# Memorandum

**RE:** Trigger Levels at Stump Springs associated with Ground Water Diversions at the

Hidden Hills Solar Electric Generating Facility

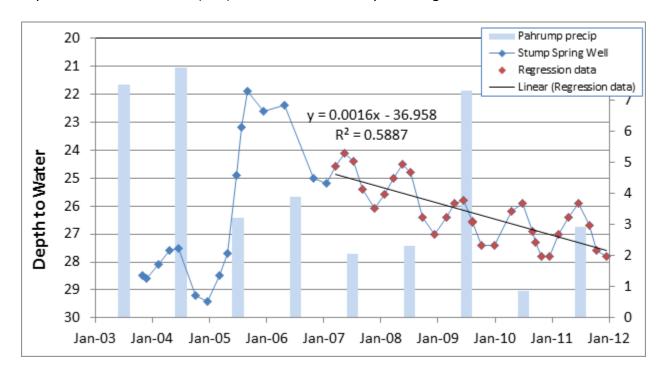
In principle, fluctuating data can be detrended *IF* data exists that we know has a direct and immediate effect on water levels. The USGS report (USGS Scientific Investigations Report 2006-5024) cited in the California Energy Commission (CEC) staff report is an example. However, the USGS report analyzed short-term (~2 weeks) data impacted by easily measurable variables such as barometric pressure. In the case of inter- and intraannual variation in water levels, detrending data is much more difficult. For example, precipitation recharge does not directly and immediately affect water levels. To find a statistical relationship for detrending requires a large data set, but even then it will be a relatively poor correlation that will yield limited usefulness for detrending. Also, if monitoring wells are to be drilled for the project, then obviously no long-term data will be available.

Analysis of Stump Springs data available from USGS indicates an overall downward trend after the 2003/2004 recharge event that can be reasonably described by a linear regression, but each year's cycle differs from the previous years. Precipitation cannot explain the annual minima (Dec) differences between years range between 0 and 0.9 ft.

Therefore, if pumping at the BrightSource has an effect on water table elevations, would be equivalent to conducting a pumping test, methods described in the USGS report can be utilized. If we are looking at long-term effects the lack of easily measurable and highly predictive variables seriously calls into question the ability to detrend the water level data sufficiently to detect a 6-inch BrightSource effect. This is especially true for wells that do not have at least a 10-yr monthly-resolution history of water level data prior to the project.
